New Coptic Orthodox Church: Archangel Michael & Gabriel Fresno, CA CUP Application

PROJECT:
Archangel Michael & Gabriel
Coptic Orthodox Church
Fresno, CA

APPL. NO. C-16-022 EXHIBIT T DATE 3-8-16

APPL. NO. C-16-022 EXHIBIT E-1 DATE 3-8-16

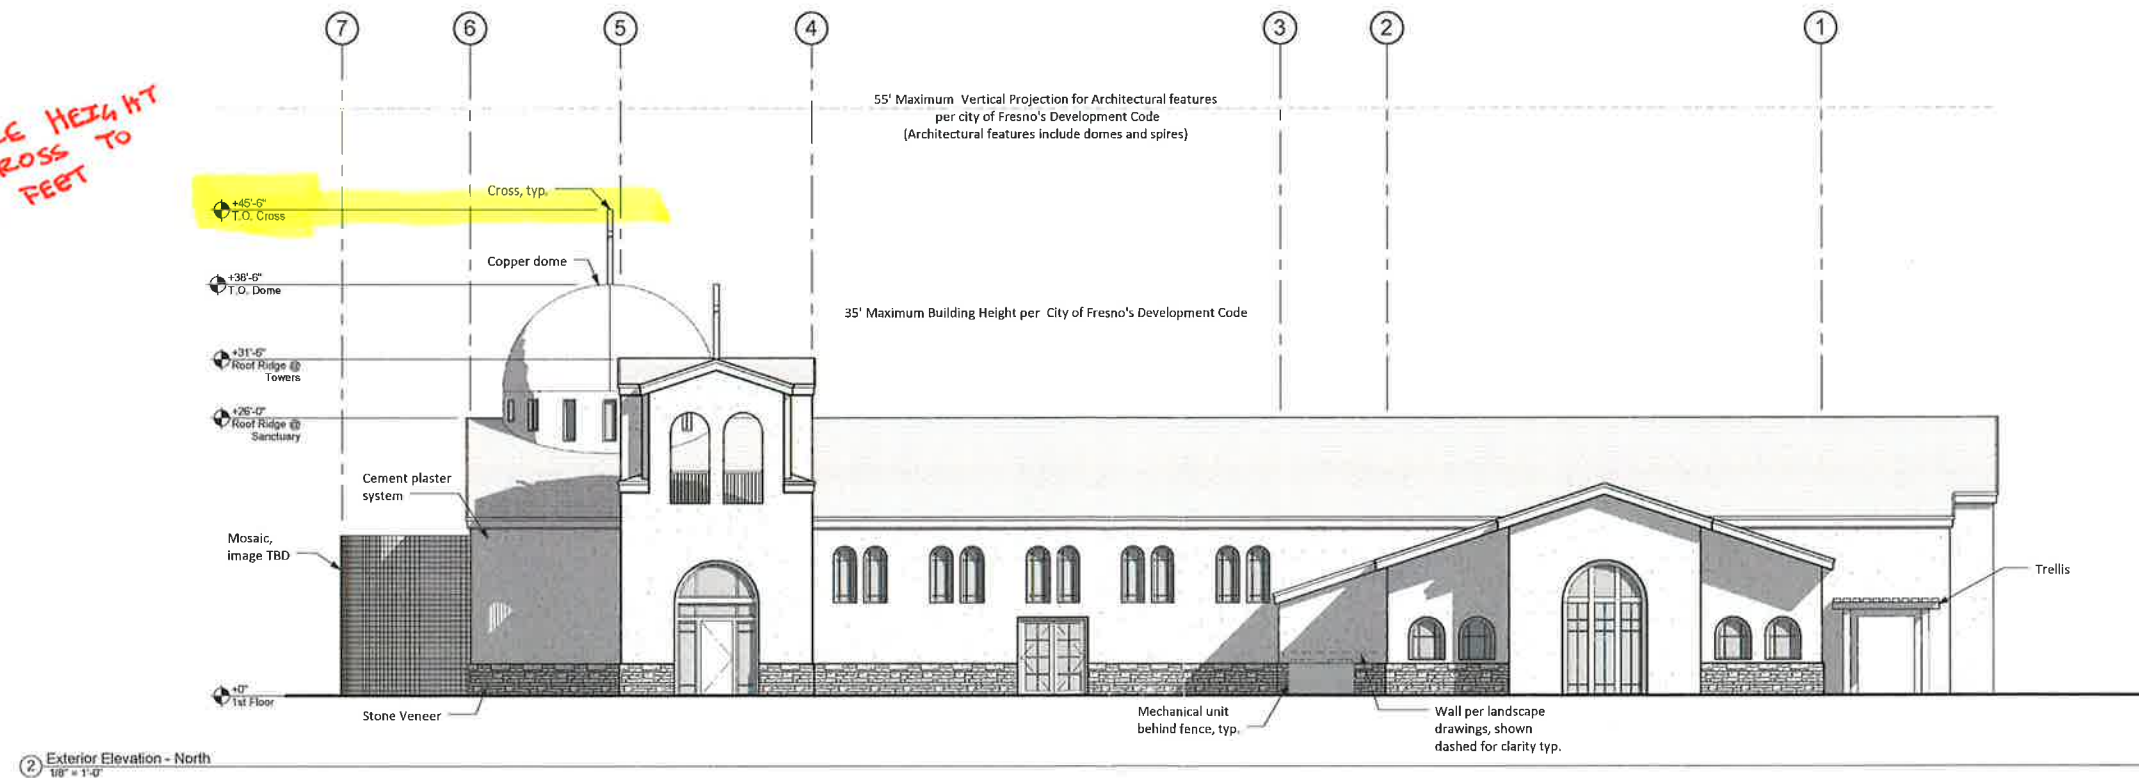
REDUCE HEIGHT OF CROSS TO 41 FEET
